TECHNICAL SERVICE BULLETIN

TSB D-LC-0039

Date: October 6, 2023
To: Internal, Sales, Distribution, and Sales Representatives
From: Technical Service Department
Subject: Inspection and Repair of DFC/DFG Condensate Drain Pan Supports

Figure 2

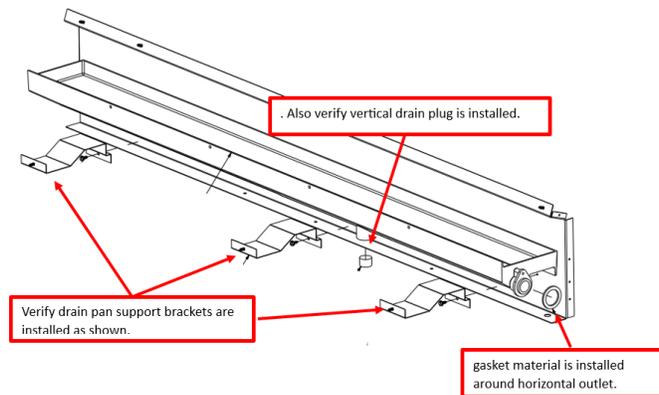
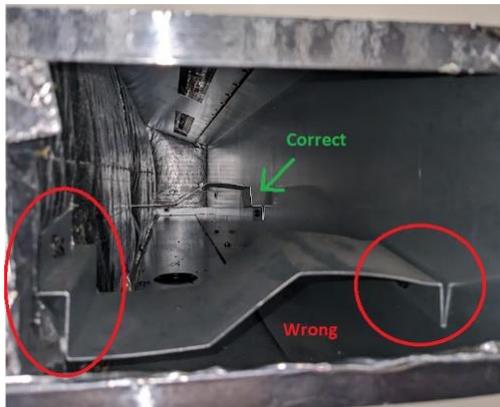
1. Remove the drain pan.
2. Inspect the drain pan for vertical drain plug and gasket or any other possible defects.
3. Inspect the support brackets.

Example of incorrect install:

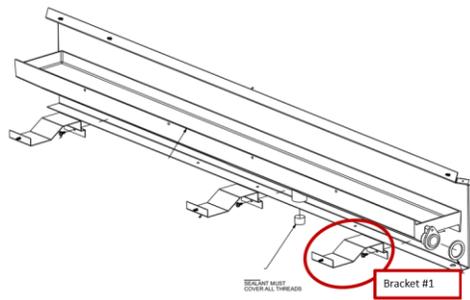
Note: If the support brackets are found to be incorrect, as shown in the image above proceed to the "Repair Process" below.

1. Reinstall the drain pan
2. Reinstall the inspection cover
3. Reconnect condensate trap

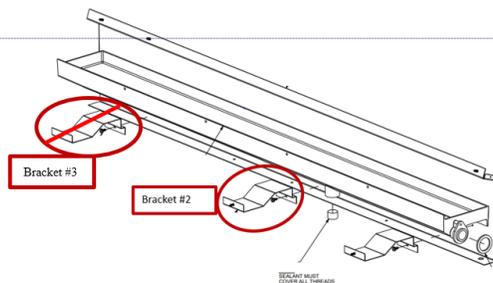
- Right angle drill attachment or equivalent (see image to the right)
 - Drill
 - Drill Extensions as needed.
 - 5/16" hex driver
1. Remove the front bracket #1 and set aside.
 - a. You will need this bracket in step number #4.

2. Remove the middle bracket #2.

Note: Bracket #3 does not need to be removed regardless of orientation.

Commented [PB1]: Jimmy Number 2 move circle and bracket number 1 to bracket 2

3. Reinstall the middle bracket #2 in the correct orientation.
4. Reinstall the front bracket #1 in the correct orientation.
5. Reinstall the drain pan.
6. Reinstall the drain pan cover.
7. Reconnect condensate trap.
